**Origination Form**  
 Proposed Revisions to a Standard Plans Index

<b>Originator:</b>	Gibbs, Shae	<b>Index Number:</b>	711-003
<b>Date:</b>	5/5/2025	<b>Sheet Number(s):</b>	2,5,6,7
<b>E-mail:</b>	shae.gibbs@dot.state.fl.us	<b>Index Title:</b>	Interchange Markings

**Summary of the changes:**

TYPICAL PAVEMENT MARKINGS AT ENTRANCE RAMPS

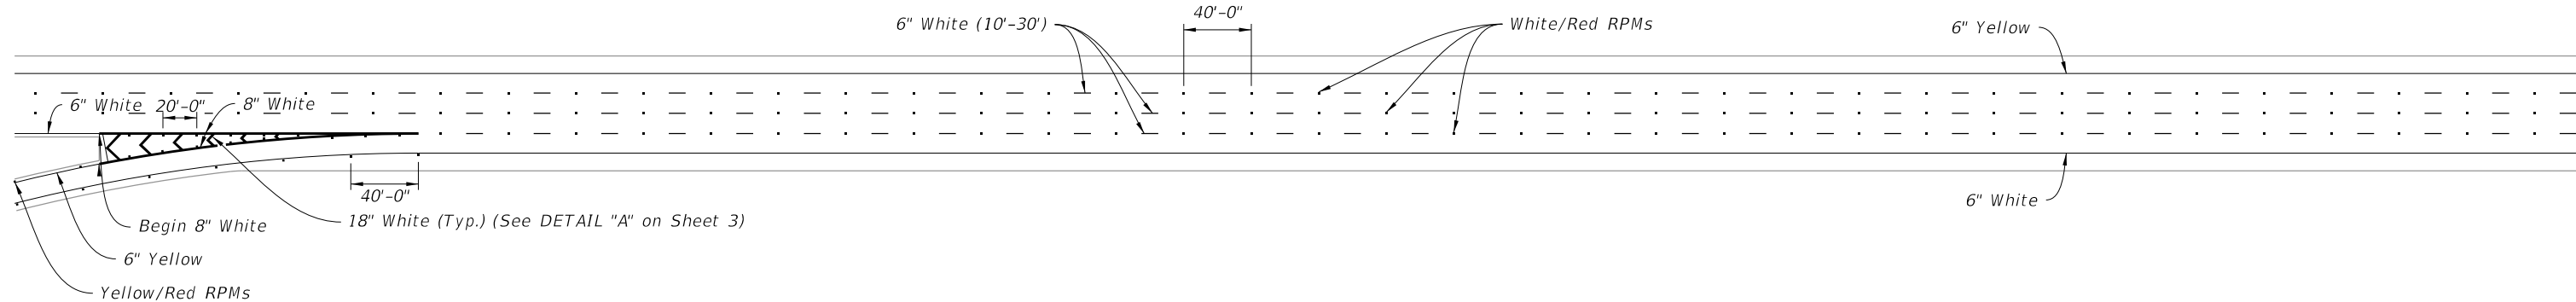
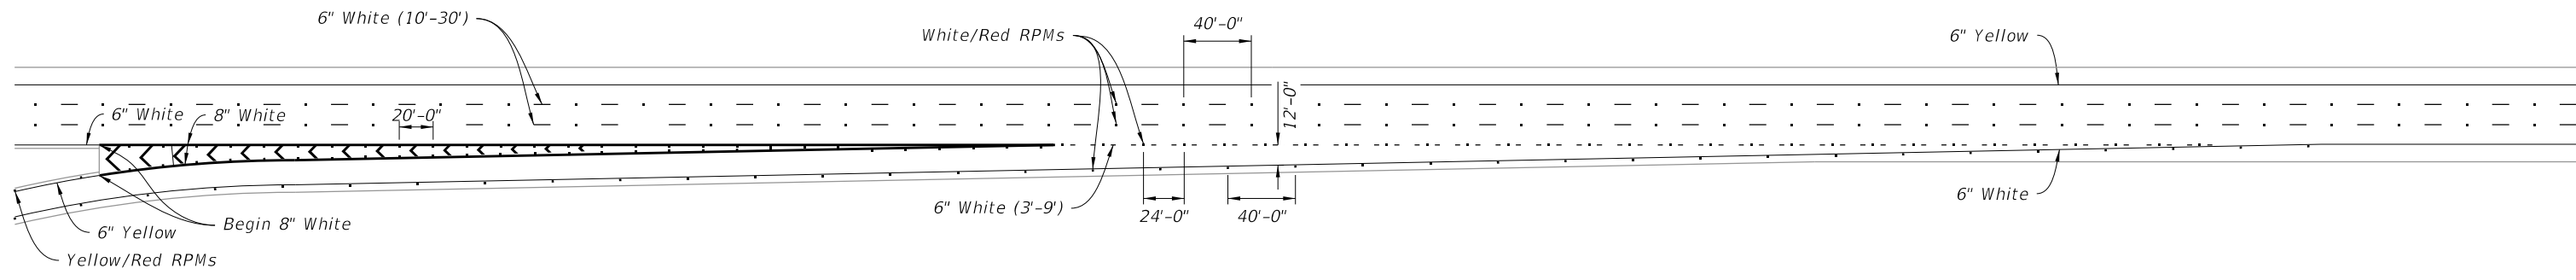
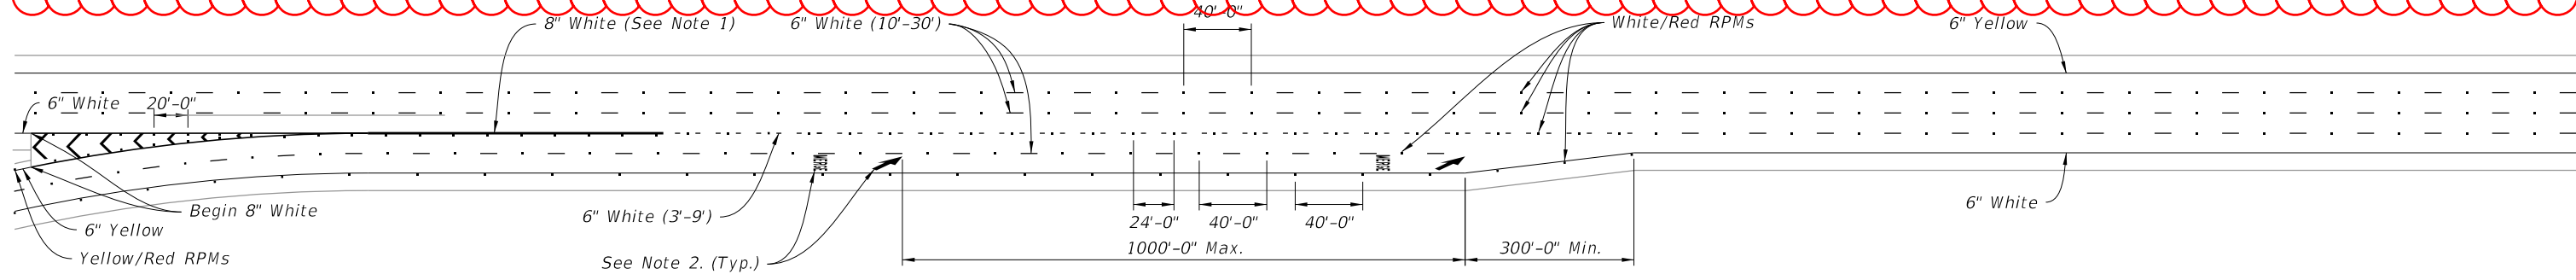
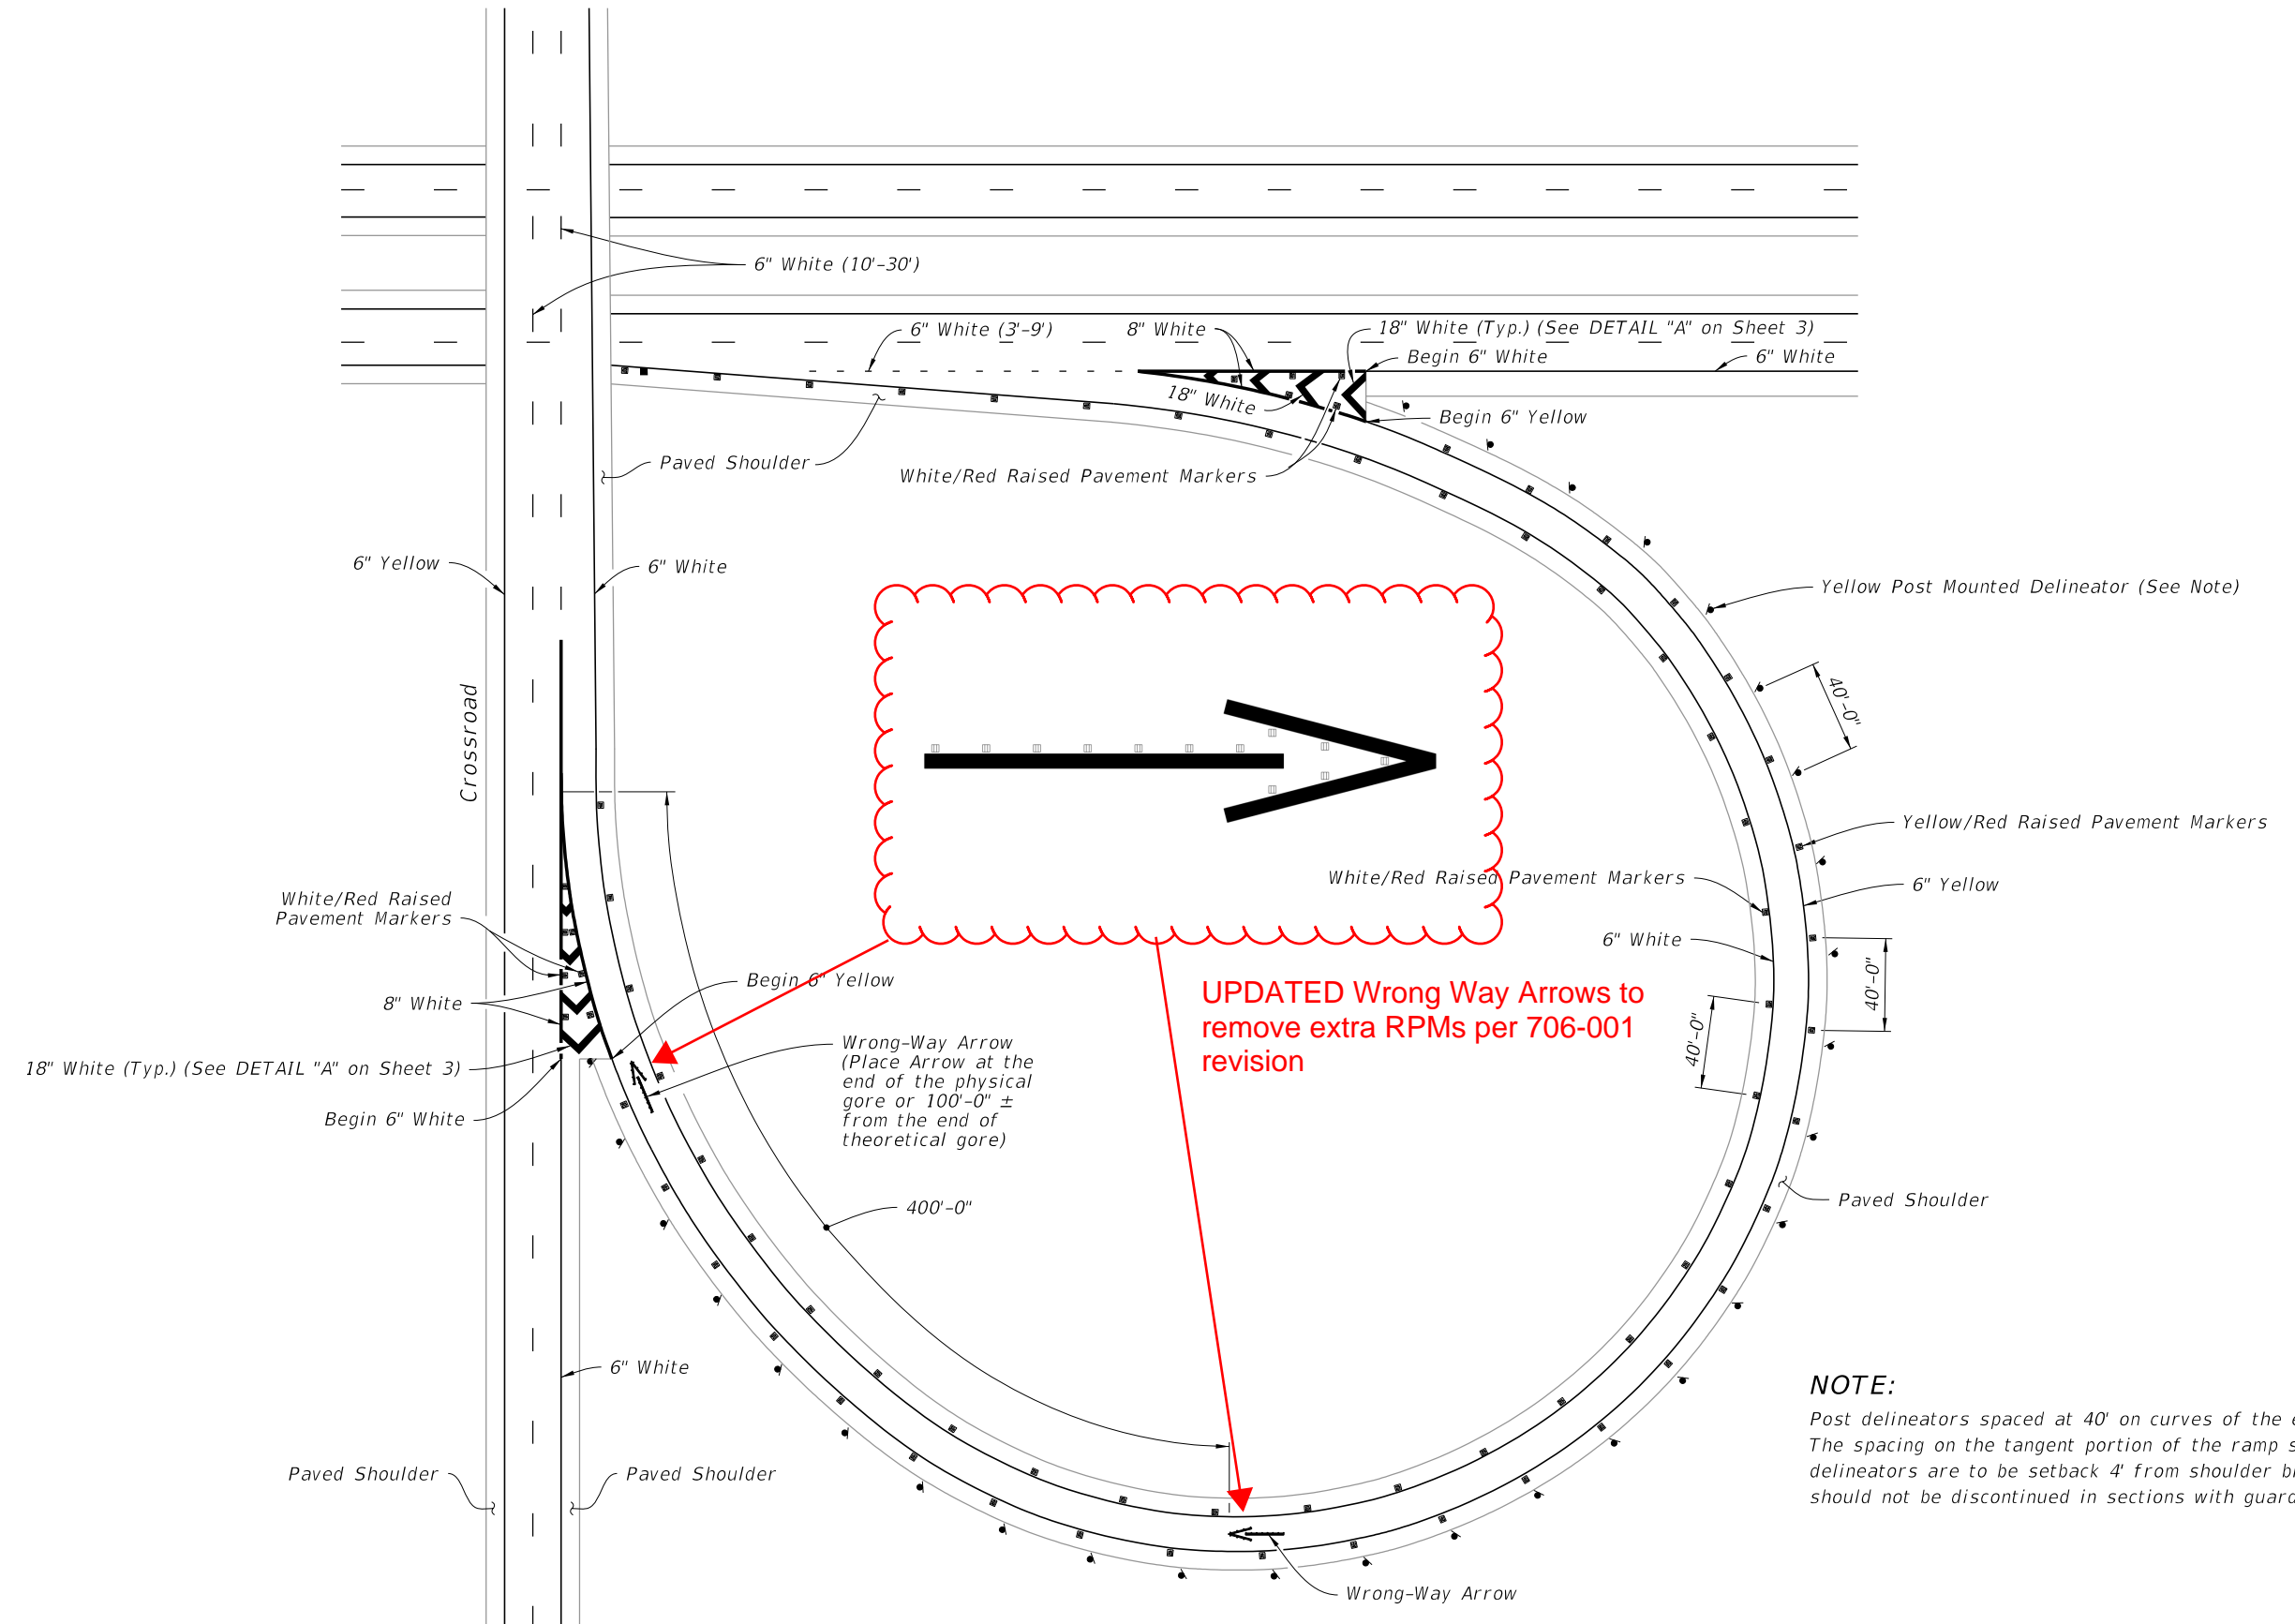
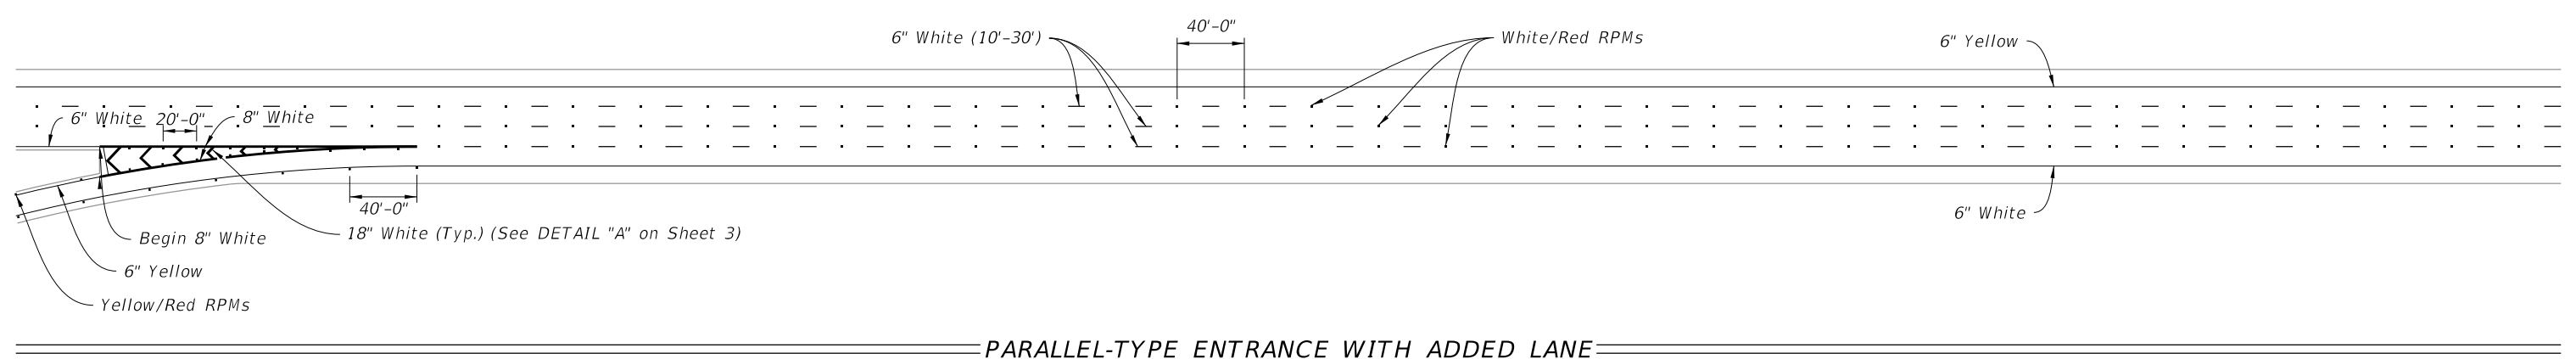
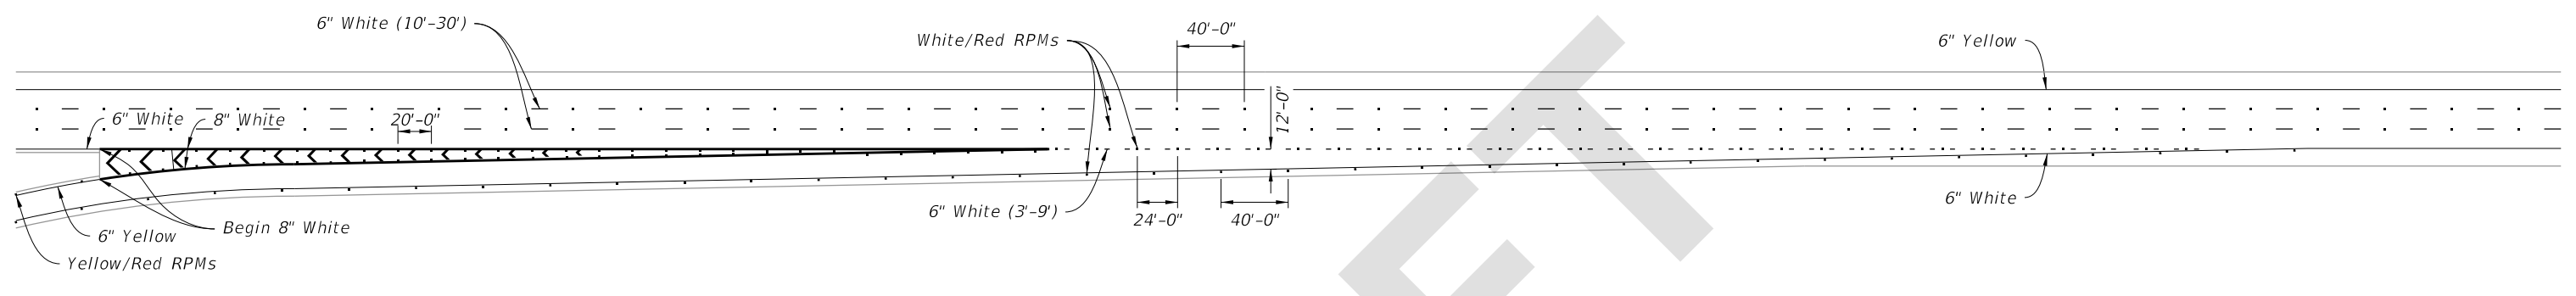
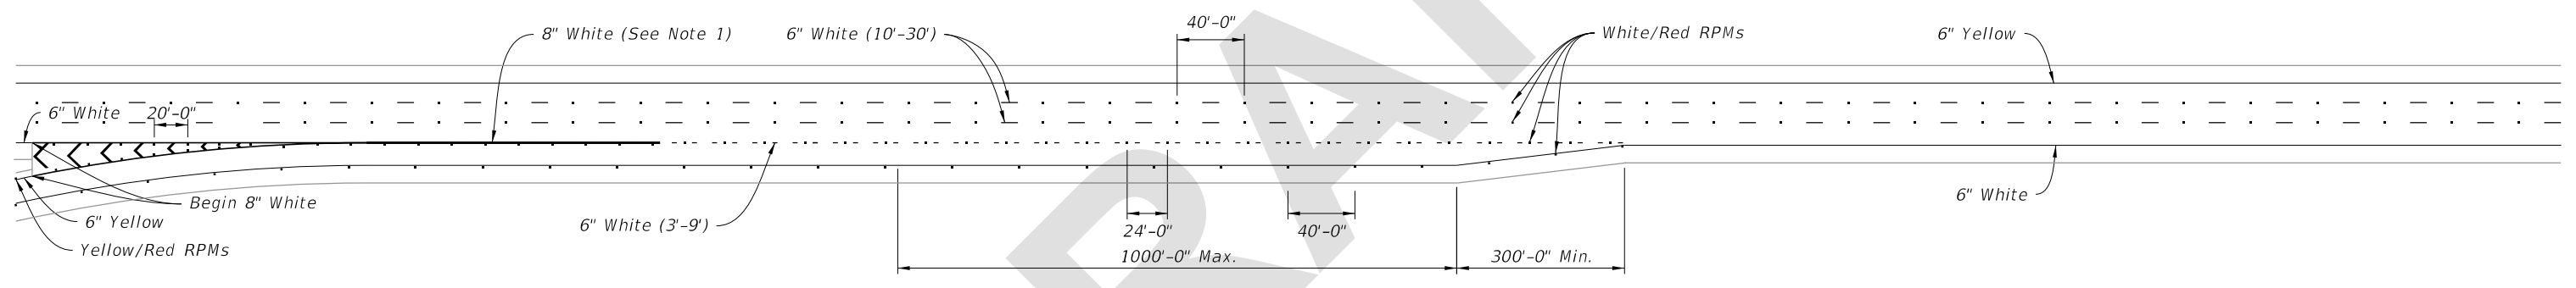
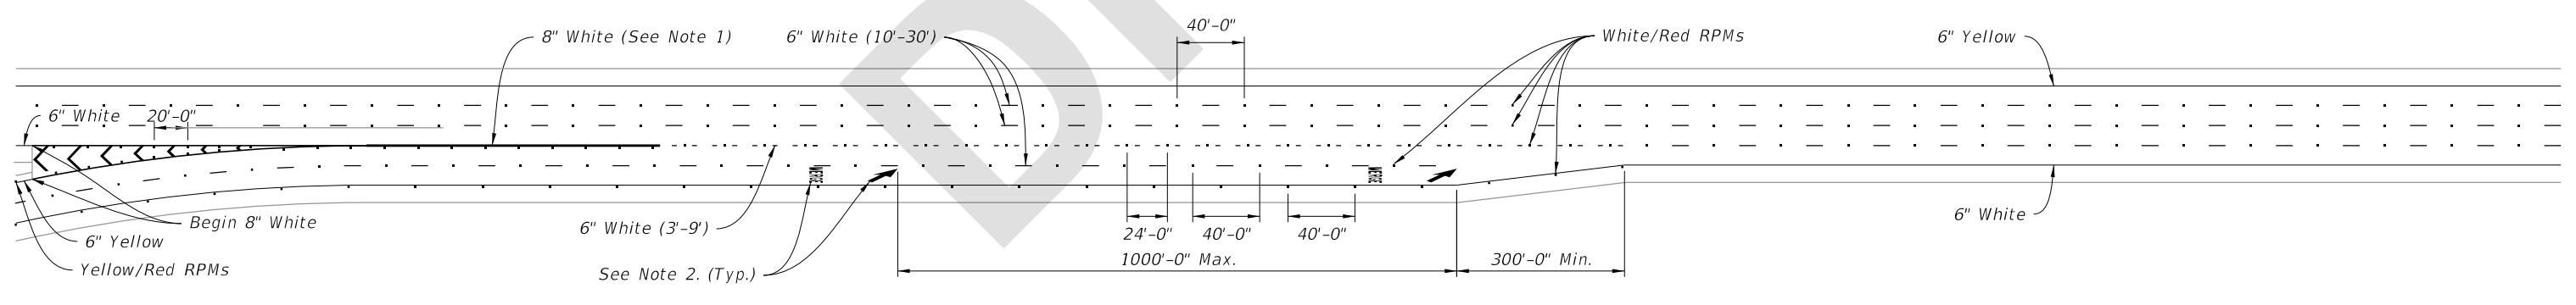
Sheet 2: Added SINGLE-LANE PARALLEL-TYPE ENTRANCE WITHOUT ADDED LANE detail.  
 Sheet 5: Updated wrong-way arrows to match 706-001.  
 Sheet 6: Updated wrong-way arrows to match 706-001.  
 Sheet 7: Updated wrong-way arrows to match 706-001, removed edge line markings from crosswalk areas.

Sheet 2: Due to ongoing confusion on what striping to use in Parallel-Type Entrances, a detail was added for SINGLE-LANE PARALLEL-TYPE ENTRANCE WITHOUT ADDED LANE for clarification

ADDED: SINGLE-LANE PARALLEL-TYPE ENTRANCE WITHOUT ADDED LANE detail
